Engineers Comments Regarding Surface Water Drainage

Application Reference:	BE/112/25/OUT	Reviewer Reference:	ADC/KW and SB
Planning Officer:	Simon Davis	Date of Review:	11/11/2025
Site Name:	Land at Heath Place, Bersted, PO22 9SL		
Application Description:	Outline application with some matters reserved (except access, layout and scale) for 3 No class E light industrial units and associated landscaping.		
Assessment Number:	1 of 1

Land at HEATH PLACE
ASH GROVE INDUSTRIAL PARK,
BOGNOR REGIS

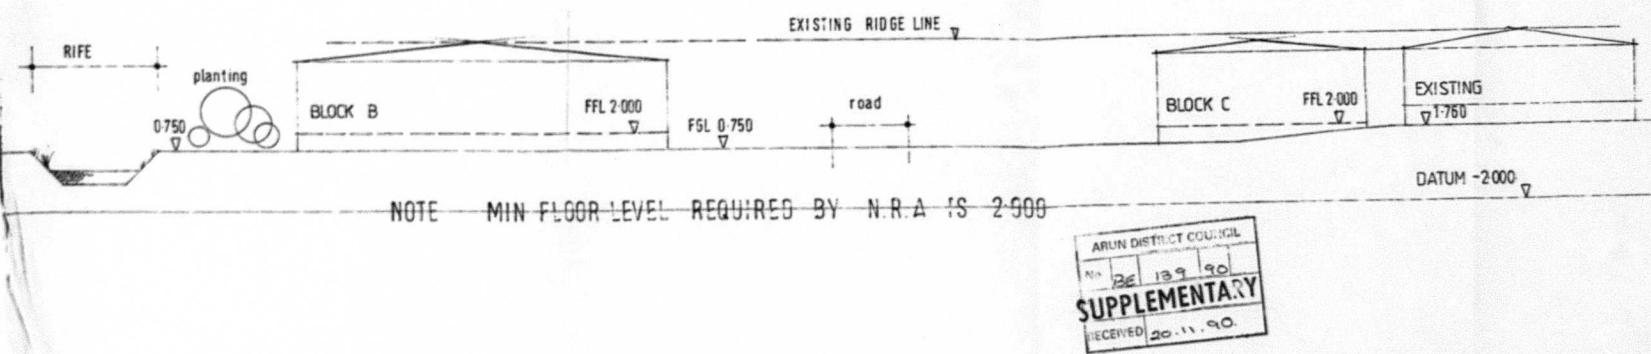
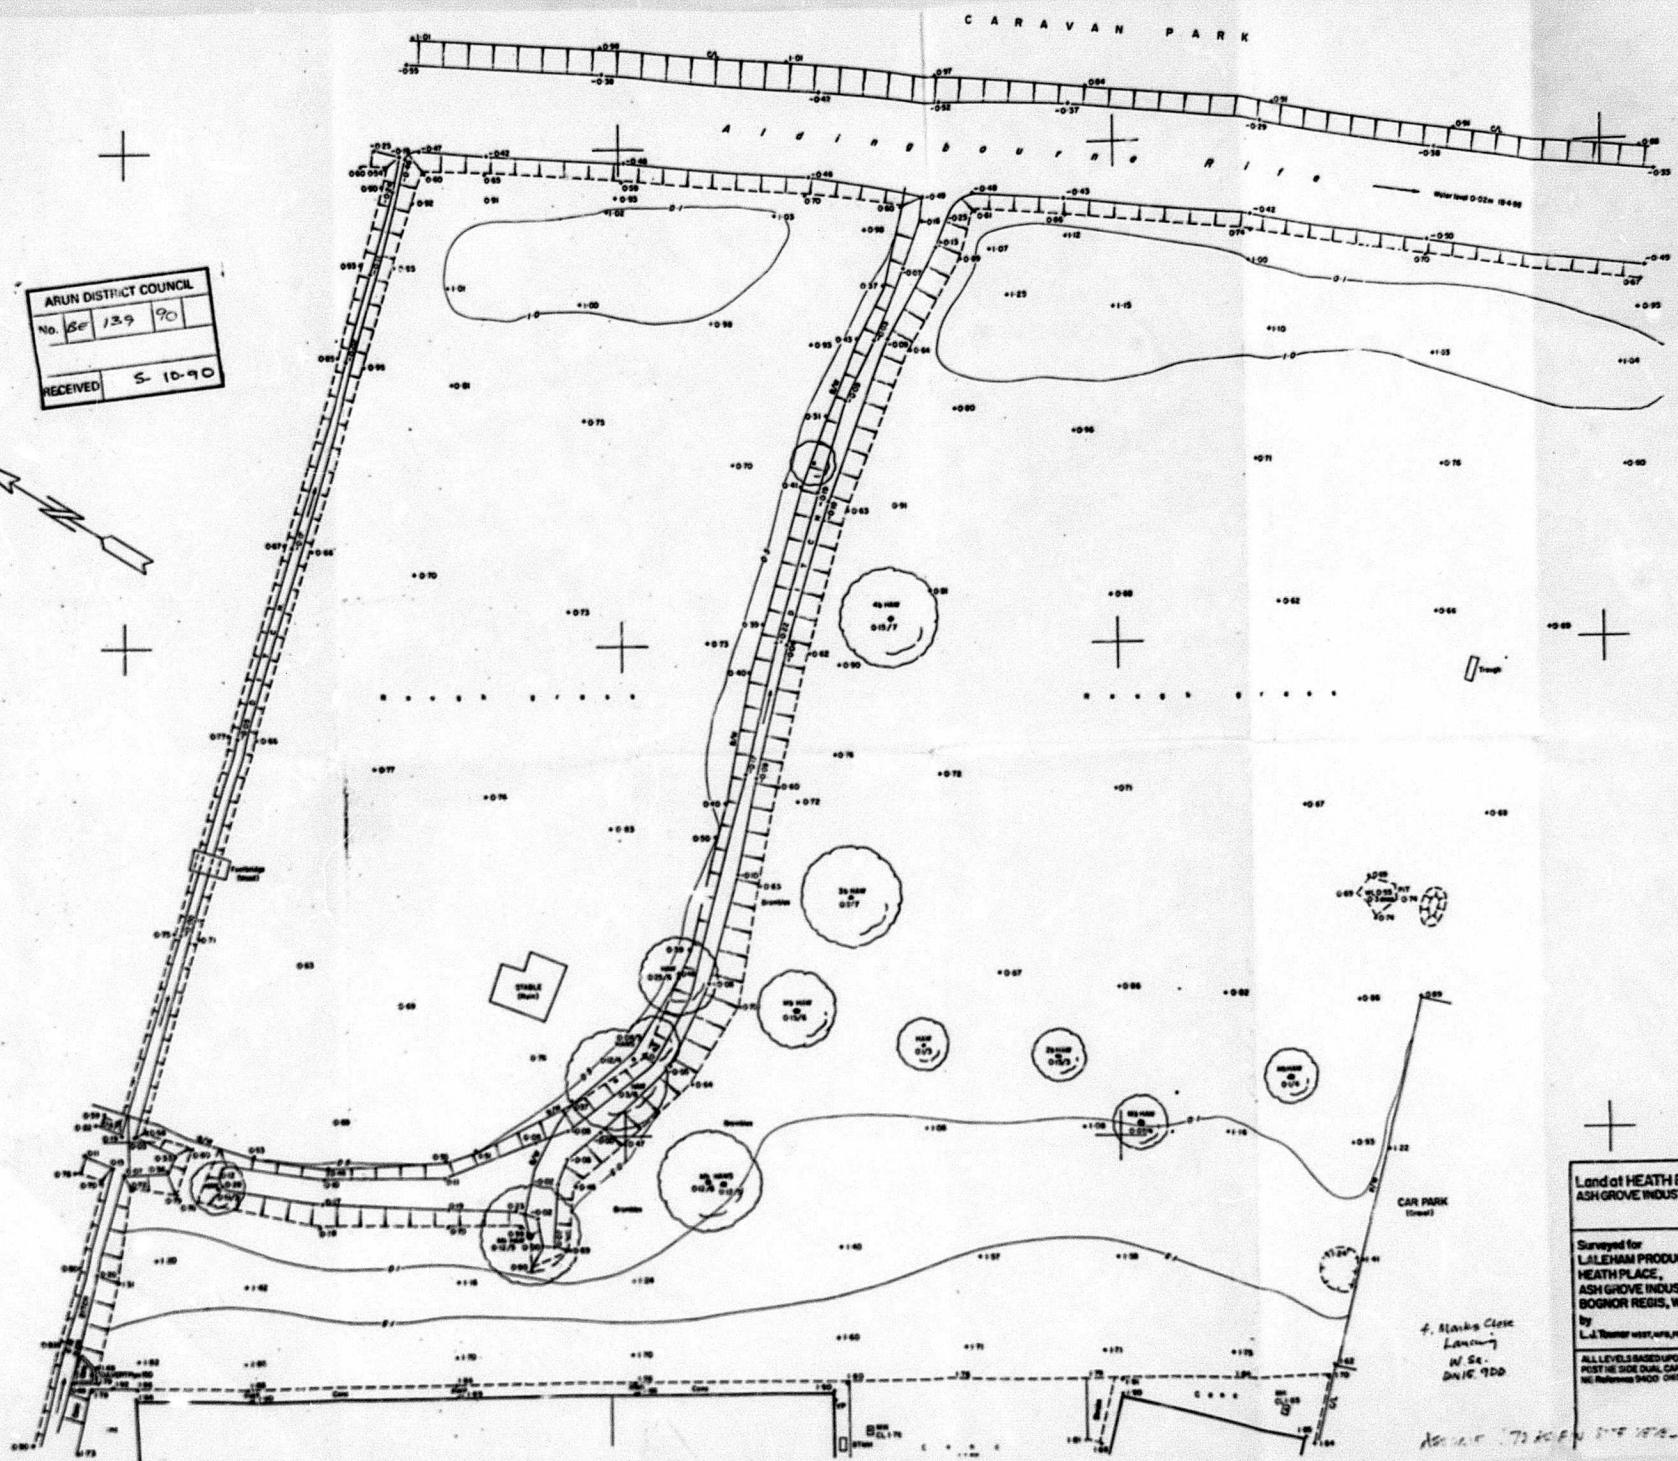
- 3.3. The planning officer and the EA are alerted to historic topographic surveys, submitted for previous planning applications which demonstrate the difference in levels on the site. These are appended to our consultation. The Ground Management report in Appendix C of the FRA also demonstrates that there is made ground to a depth of 0.9m which aligns with expected pre-application ground raising on the site.

- 3.4. The same historic topographic surveys and ordinance survey maps demonstrate that there was, or should be a watercourse running through the centre of this site. It is apparent from this submission that the watercourse has been infilled. It is unclear if the site owner had consent for this action which is expected to have increased flood risk.
